CALIFORNIA COASTAL COMMISSION

REVISED CONDITIONS AND FINDINGS

Appeal No.: A-6-OCN-13-008

Location: 1513 South Pacific Street, Oceanside (San Diego County)

SHEET TITLE:
EXTERIOR ELEVATIONS
SHEET NO.:
A.3

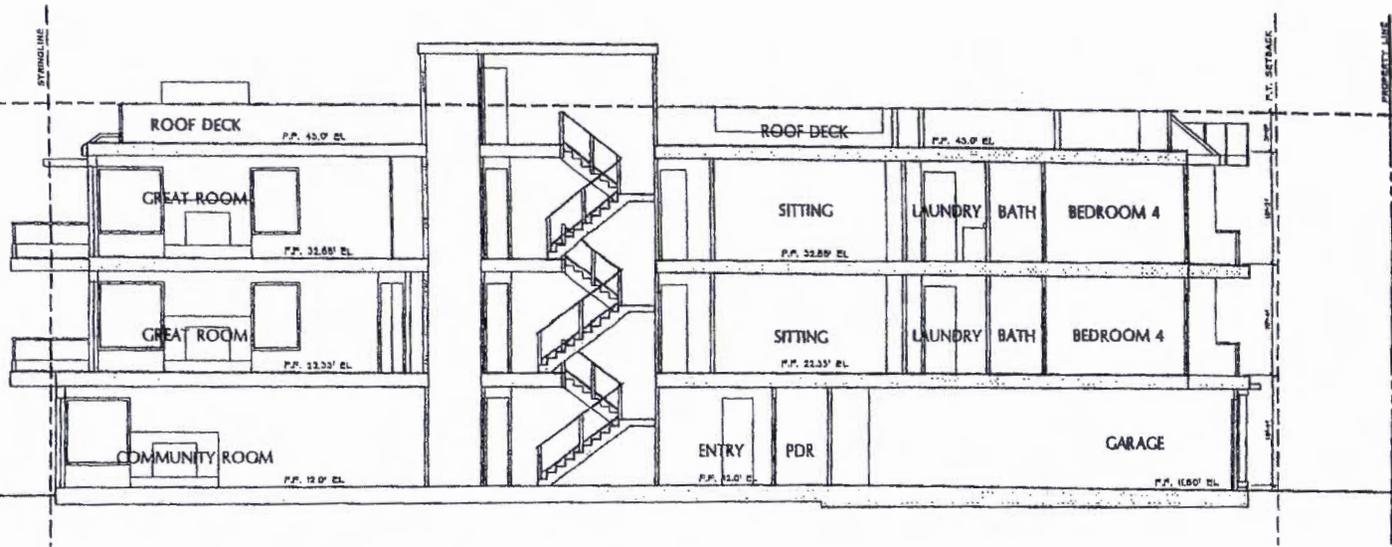
- b. ~~Along the south side of the site, the second level shall be revised to be “stepped back” from the first level at a minimum of 10 ft. for the entire length, front to back, of the proposed structure so as to reduce ocean view impacts (combined with subsection “a” above to generally follow revisions noted in alternative’s Option #3)~~

As such, **Special Condition 1.a** requires the applicant to submit final plans with the proposed building located no higher than 27 feet tall. By limiting the height of the structure to 27 feet, an appropriate transition will be provided between the larger scale developments in the north and south (both constructed pre Coastal Act), and the open space and smaller scale developments immediately surrounding the subject site. **Special Condition 1.a** will also allow for certain appurtenances greater than 27 feet elevation, provided that such appurtenances do not obstruct coastal views. Allowing such appurtenances is comparable to what was authorized by the Commission on the adjacent lot, and would continue to provide an appropriate transition between Buccaneer Beach (undeveloped sandy beach) and the much larger, pre coastal condominium complex to the south. Therefore, only as revised through **Special Condition #1** can the project be found to be in similar scale to surrounding structures consistent with the City's certified LCP.

EXHIBIT NO. 4
APPLICATION NO.
A-6-OCN-13-008
Applicant photo of
view at Morse Street

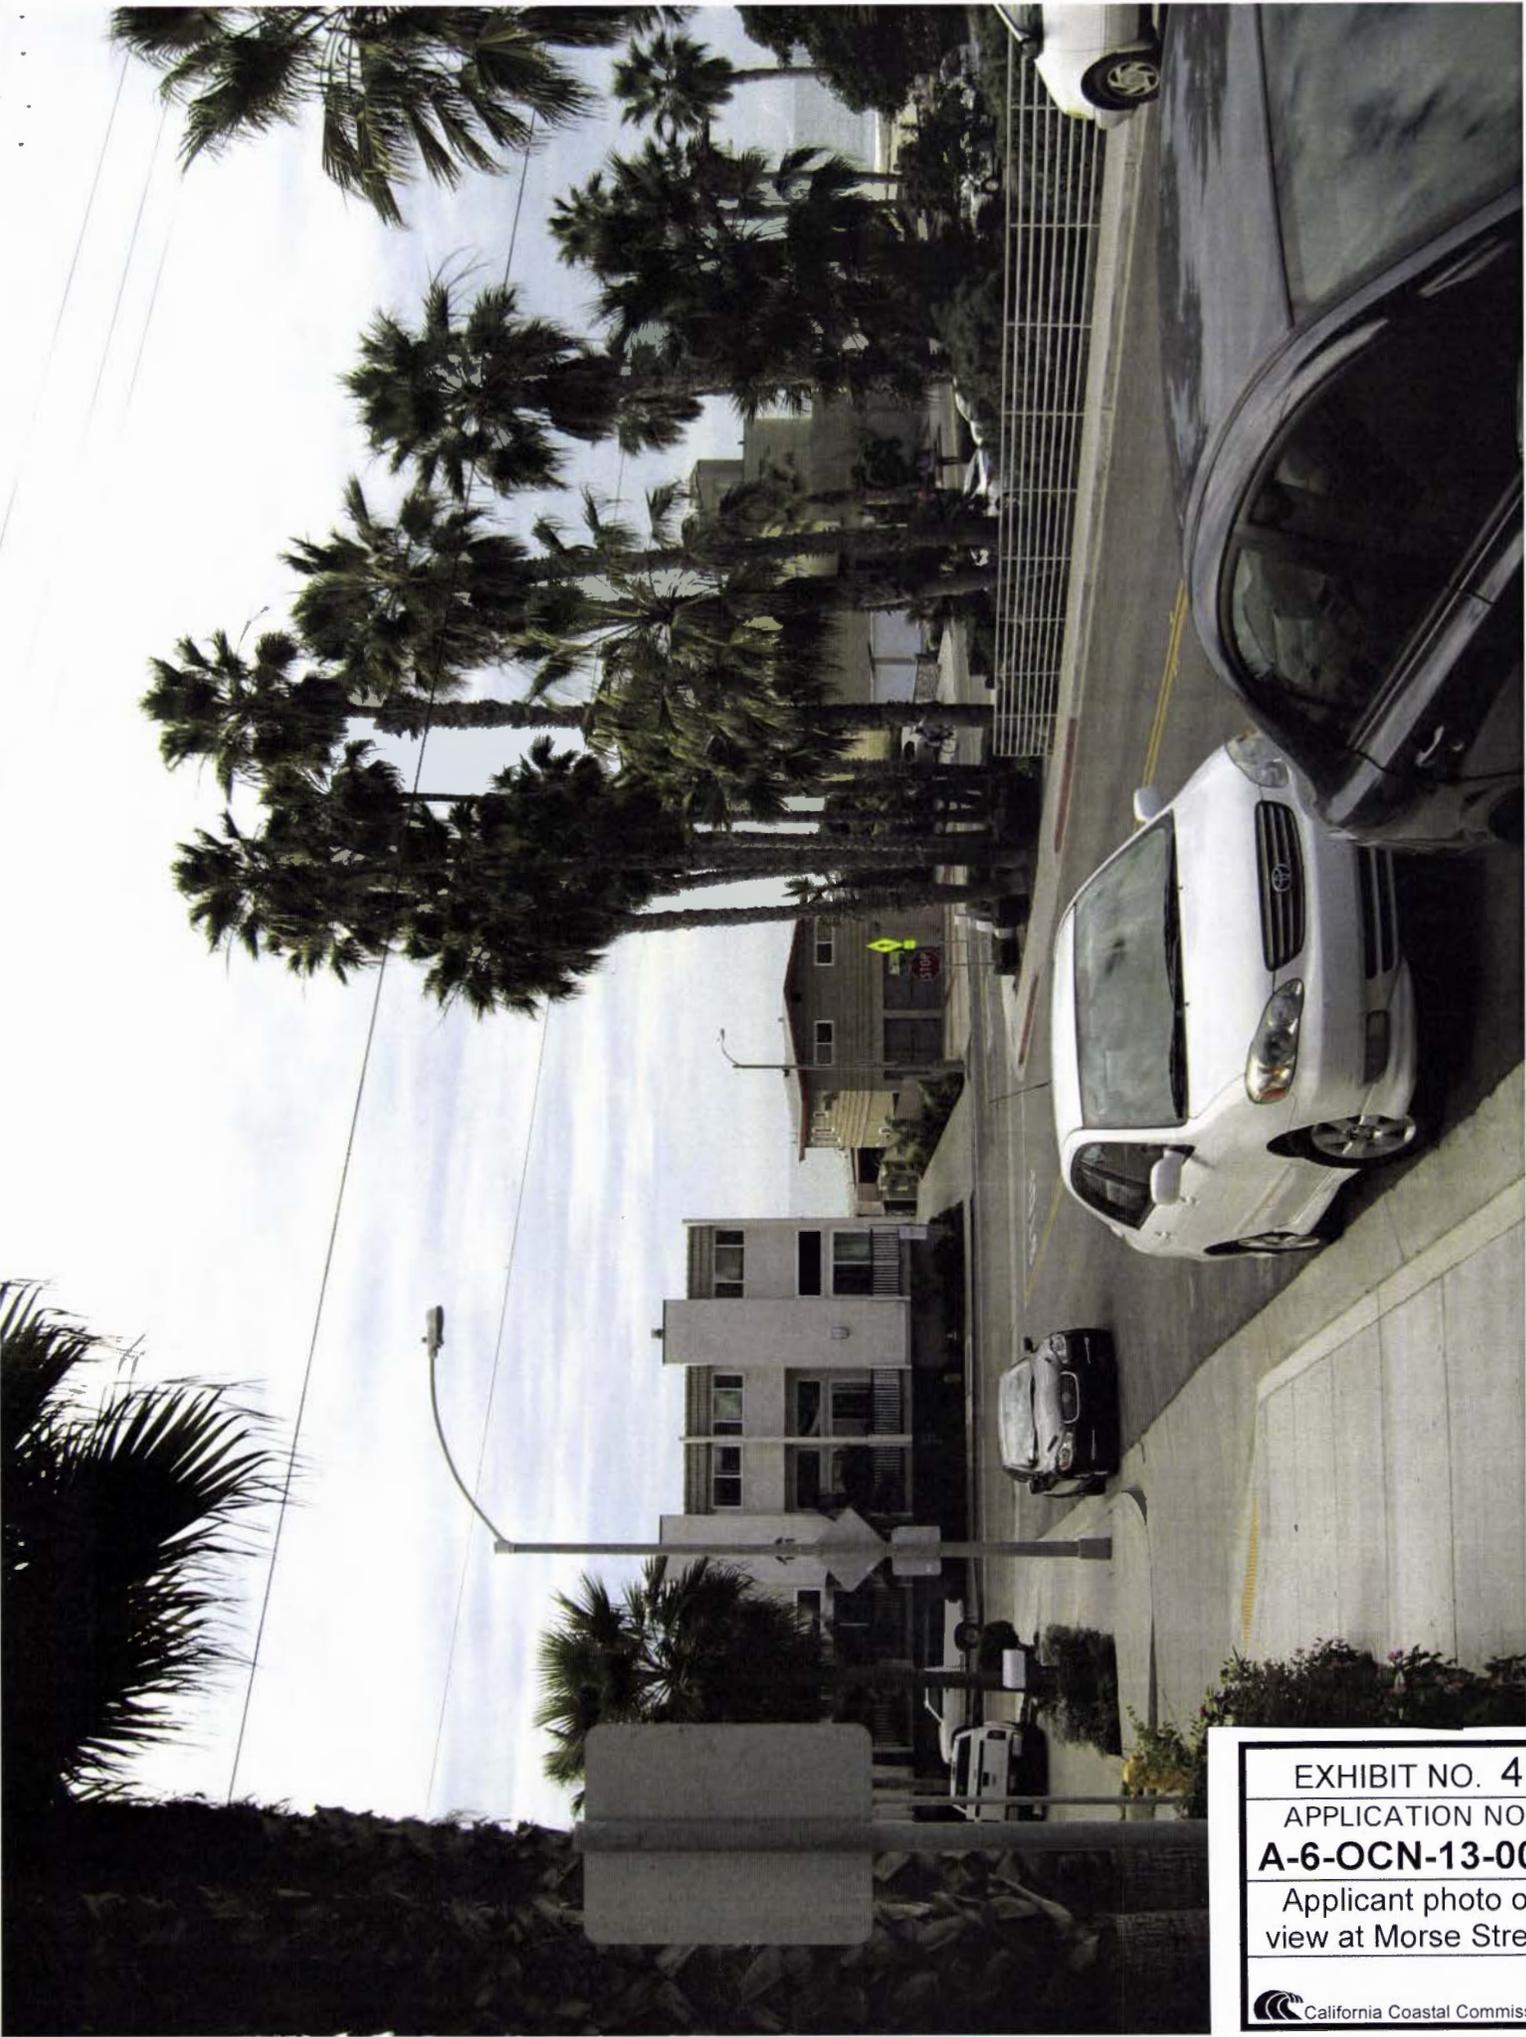
Currently, views of the ocean exist from Morse Street, between Myers Street and South Pacific Street, across the site. These views exist because the development on the property to the south has a large side yard setback that is used to provide access to the underground parking garage and because the west side of the subject property is currently developed with a single-story structure that stands under 12 feet tall (ref. Exhibit #14). Thus, the public is afforded views of the ocean while traveling west on Morse Street as viewed across both the undeveloped section to the south and above the single story home on the west side of the subject site. Morse Street is an east-west facing street that ends just inland of the subject site (ref. Exhibit Nos. 1 & 14). Views of the ocean from east-west facing streets have been identified by the City's LCP as areas where ocean views may be provided. In a survey of the east-west public streets that dead-end at the ocean or at N. Pacific Street or S. Pacific Street in Oceanside, 24 out of 25 of those east-west streets (Eaton St. is the exception being adjacent to a private development that is not open to the public), including Morse Street, maintain views of the ocean. Of those 24 east-west streets with views of the ocean, Morse Street has the most limited view of the ocean., which further magnifies the importance of preserving the view from Morse Street between the subject site and the development to the south of the subject site by limiting the amount of development in that view corridor. Morse Street also provides access to Buccaneer Beach, Buccaneer Park, and

facilitates a portion of the City's citywide bike trail; and therefore, the protection of views from Morse Street are considered to be important. As such, **Special Condition #1** is proposed, which requires the applicant to submit modified final plans that will reduce the view obstruction associated with the proposed structure. In addition, the project site is located three lots south of Buccaneer Beach; which provides expansive and unobstructed views of the ocean. The majority of public view opportunities while traveling along Morse Street are obstructed by vegetation in the City's right-of-way. Thus, while the views from Morse Street generally are protected by the City's LCP, in this case, the views are minimal and obstructed, and absolute preservation of these views is therefore not appropriate in this case. In addition, the proposed structure would have to be significantly revised, including the removal of the entire third level, and a major reduction in the second level in order to protect such views. That being said, there are adjustments that can be made to the design of the structure that will protect a portion of the public views. These include stepping back the structure on the west side of the property to be consistent with the established western or "stringline setback," and designing all decks and balconies to be transparent. Modifying the structure to be consistent with the stringline setback will only require the minimal redesign of the structure, specifically the building length of the structure will need to be decreased on the western side between 1.5-4.5 feet. In addition, in order to protect any views within the sideyard areas, all vegetation in the sideyards will be limited to a height of three feet or less, and all sideyard fencing will be designed to be 75% open the light. Through these minimal redesign efforts, a portion of the existing views from Morse Street will be maintained, and new views through the sideyard areas will be created, consistent with the intent of the City's LCP. As such, **Special Condition Nos. 1 & 11** have been included and incorporate all the discussed project modifications appropriate to maintain a portion of the existing public views.

EXHIBIT NO. 9
APPLICATION NO.
A-6-OCN-13-008
Redesign Option #1
rendering

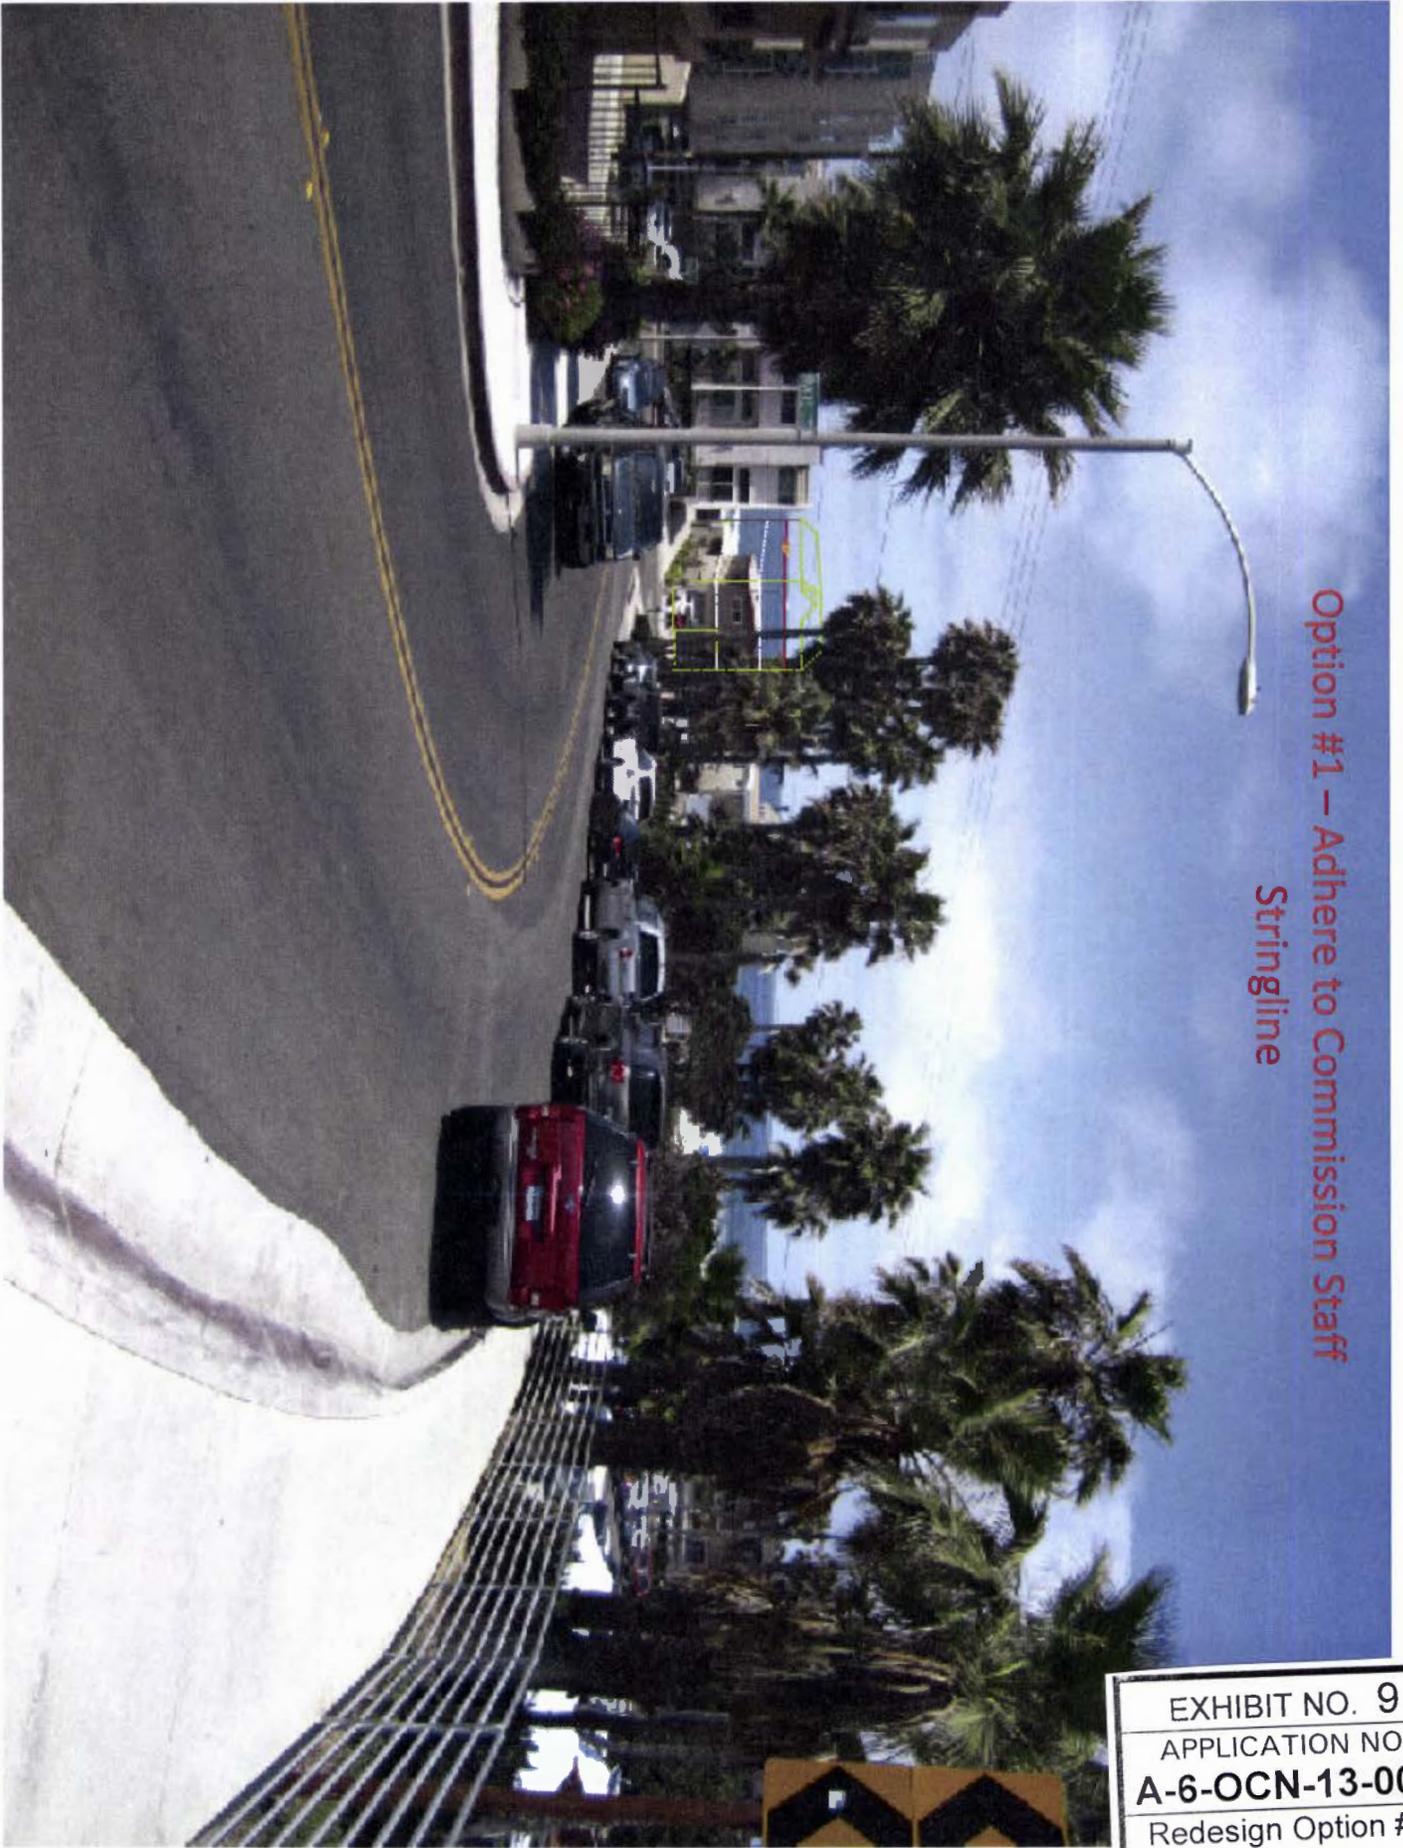
Option #1 includes moving the entire project inland/east by approximately 1.5-4.5 feet, which would reduce the size of the structure by a total of 177 sq. ft. (ref. Exhibit #9). This option will result in a home located further inland, and thus provide a small view of the ocean from Morse Street; however, by bringing the home inland between 1.5 and 4.5 feet, only a very small portion of the existing ocean views would remain. ~~Because Option #1 does not adequately protect all existing views from Morse Street, Option #1 was not determined to be the least impactful alternative.~~ Option #2 includes the removal of the entire third level, which would reduce the structure by a total of 2,350 sq. ft. (ref. Exhibit #10). ~~However, while some horizon views would be captured with this alternative, the existing views of the ocean exist below the height of the third level. Thus, by only removing the third level, no existing views of the ocean will be protected. Again, because Option #2 does not adequately protect existing views, it too was determined to not be the preferred alternative.~~ Option #3 includes removal of the third level and stepping back the south side of the structure on the second level by 10 feet, which would reduce the structure by a total of 3,380 sq. ft. (ref. Exhibit #11). ~~By removing the third level as well as the southern section of the second level, Option #3 would allow for some horizon views and protect the majority of the existing ocean views and is thus considered a viable alternative.~~ Option #4 includes narrowing the second and third floors by 10 feet, which would reduce the structure by a total of 2,060 sq. ft. (ref. Exhibit #12). ~~Option #4 also would protect a significant portion of the existing ocean views and is also, therefore, considered a viable alternative.~~ The final option, Option #5, was described by the applicant as the option that would completely eliminate all view obstructions and includes removal of the third level and stepping back the southwestern edge second level, which would reduce the structure by a total of 2,840 sq. ft. (Option #5, ref. Exhibit #13). Again, Option #5 would protect the existing public views, and thus is a feasible alternative. However, it is important to note here, that staff is not certain that the applicant's assertion that Option #5 will actually completely eliminate any view obstruction and is discussed further in the paragraph below. In addition, while the applicant has agreed to and submitted the alternatives analysis, the applicant has indicated that the loss of square footage associated with any option provided is undesirable and therefore, no redesign is being proposed by the applicant.

As such, **Special Condition #1.b.** requires the applicant submit revised final plans that include stepping back west side of the structure between 1.5-4.5 feet. the second level by ten feet for the entire depth of the lot. In addition to redesigning the enclosed portion of the house, measures need to be included that will also address potential public view impacts associated with accessory structures such decks and balconies as well as landscaping within the setback areas. As such **Special Condition #1.ae.** requires the project be designed to include that all above ground railings for decks and balconies be transparent. In order to protect potential bird strikes on the transparent glass, **Special Condition #1.c,** requires that all transparent railings, windows, etc., shall use materials designed to minimize bird-strikes. In addition, in order to keep the side yards open and avoid walling of the site as viewed from the street, **Special Condition #12** requires all proposed landscaping in the side and front yard areas be maintained at a height of three feet or lower (including raised planters) and that any fencing in the side yard setback areas shall have at least 75 percent of its surface area open to light for the life of the proposed development. In this way, public views from the street toward the ocean will remain open along the side yards as viewed from South Pacific Street and Morse Street. Finally, **Special Condition Nos. 9, 10, & 11** require the submittal of as-built plans, require that all future development be reviewed by the Coastal Commission, and require the recordation of a deed restriction respectively. These conditions will ensure that the structure is built as approved by the Commission, and that all future development will be sited consistent with the established stringline setback for this section of the City.

EXHIBIT NO. 15
APPLICATION NO.
A-6-OCN-13-008
Commission staff
stringline location

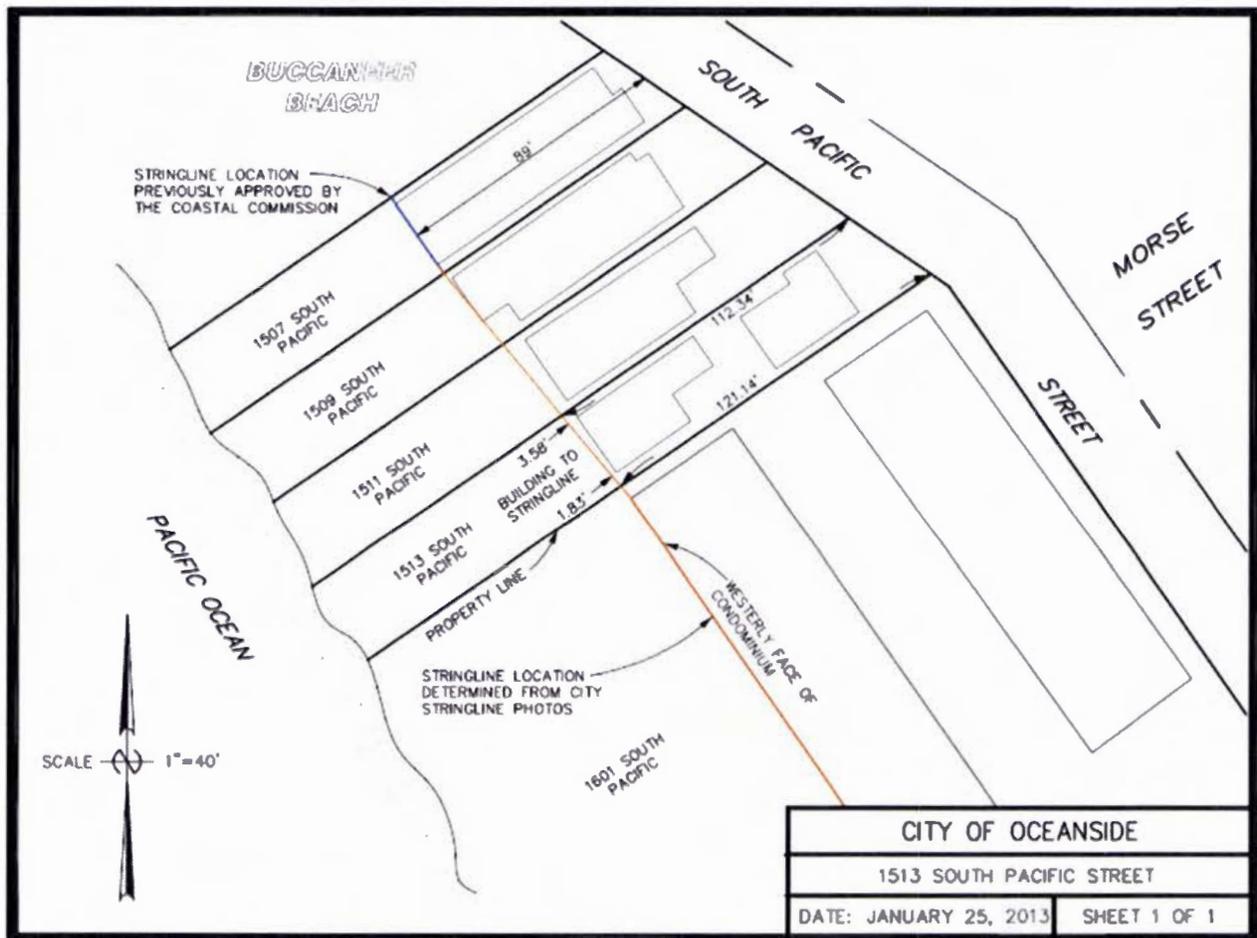
The rear yard setback, therefore, has been determined by drawing a line connecting the Stroud residence on the north side (1507 South Pacific Street) and the existing pre-coastal condominium

In addition, the proposed project may also have cumulative impacts on public views through the creation of a new precedent. The use of appurtenances as a point from which to measure a stringline for proposed development may encourage shorefront property owners to seek to use decks and walls beyond the City's established stringline points both on the immediately adjacent properties, as well as City-wide which may also encroach into existing public views, similar to the proposed development. As such, **Special Condition #1** requires the applicant to submit final plans that redesign the structure to be consistent with the stringline setback 112.34' west of the property line on the north side of the property 121.14' west of the property consistent with previous Commission action and as recommended by the City's planning staff. However, decks, balconies, wingwalls, etc., may extend beyond this setback, if approved by the City of Oceanside. In addition, **Special Condition Nos. 8, 9, & 10** require the submittal of as-built plans, require that all future development be reviewed by the Coastal Commission, and require the recordation of a deed restriction respectively. These conditions will ensure that the structure is built as approved by the Commission, and that all future development will be sited consistent with the established stringline setback for this section of the City.
